10/598,489

Office Action Summary	Application No. 10/598,489	Applicant(s) KE ET AL.	
	Examiner Tuan N. Nguyen	Art Unit 3751

DETAILED ACTION

Fig.2
PRIOR ART

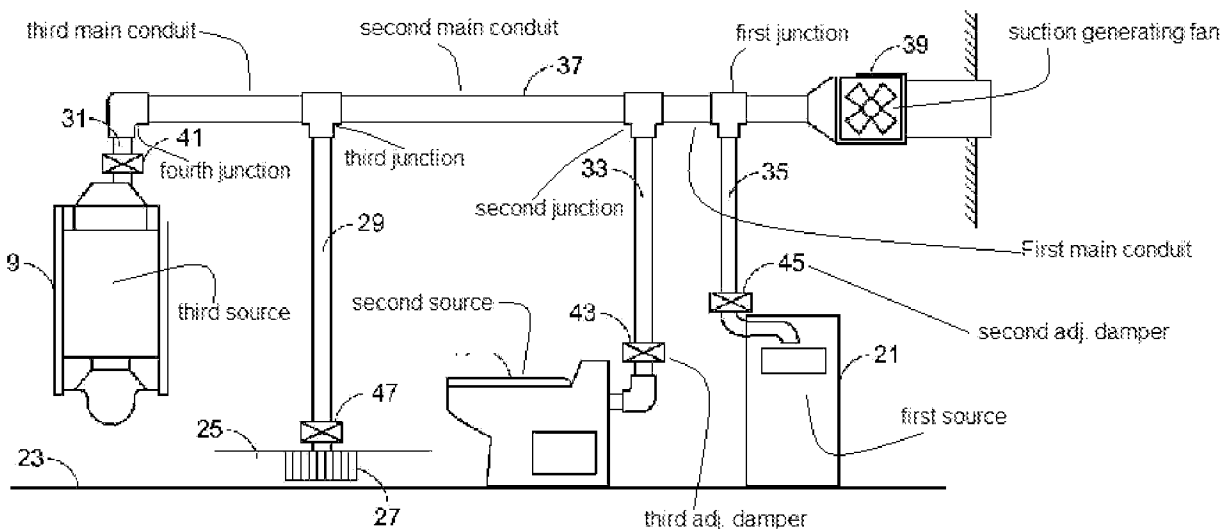
2. Claims 1-4, 6 and 7 are rejected under 35 U.S.C. 103(a) as being unpatentable over admitted prior art Fig. 2 (as shown below) in view US 3,942,200 (hereinafter Pearson).

The prior art Fig. 2 lack a “first adjusting damper” position in the first main conduit between the first and second junctions as claim. However, Pearson teaches adding ventilators/adjusting dampers (8) which is a butterfly valve (see col. 5, lines 36-43) to a main conduit to control the airflow pressure from odor generating sources from one

central exhaust system. Therefore, it would have been obvious to one having ordinary skill in the art at the time the invention was made to employ, on the main conduit of prior art Fig. 2, an adjusting damper as taught by Pearson to control the airflow pressure from odor generating sources from one central exhaust system. The place of the adjusting damper between the first junction and second junction would be well within skill one of ordinary skill in the art which would be depend on what odor source he/she wishes to control. The same reason would applied for adding an fourth adjusting damper to the second main conduit.
